NEW MODEL - 26ER8BA

The following updates are required for the user of this Manual to reflect changes in the RIDER MOWER on Models 26ER8BA.

191B4618 R-0

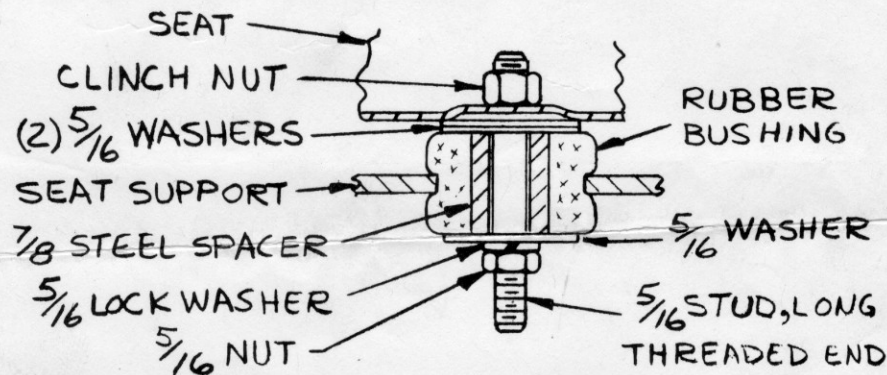
1. The method of mounting the seat to the RIDER (Page 20, Figure 22) is changed to the following procedure.

SEAT MOUNTING: THE ER8-36 RIDER USES A SEAT SWITCH FOR OPERATOR SAFETY TO INSURE PROPER OPERATION OF THIS DEVICE ASSEMBLE SEAT AS SHOWN.

INSTALL STUDS (SHORT THREADED END) INTO SEAT. WRENCH ON NON THREADED PORTION OF STUD. BOTTOM THREAD AGAINST SEAT CLINCH NUT. TIGHTEN $\frac{5}{16}$ NUTS SUCH THAT THE RUBBER BUSHINGS ARE FULLY COMPRESSED AND THE FLAT WASHERS BOTTOM ON THE $\frac{7}{8}$ LONG STEEL SPACER.
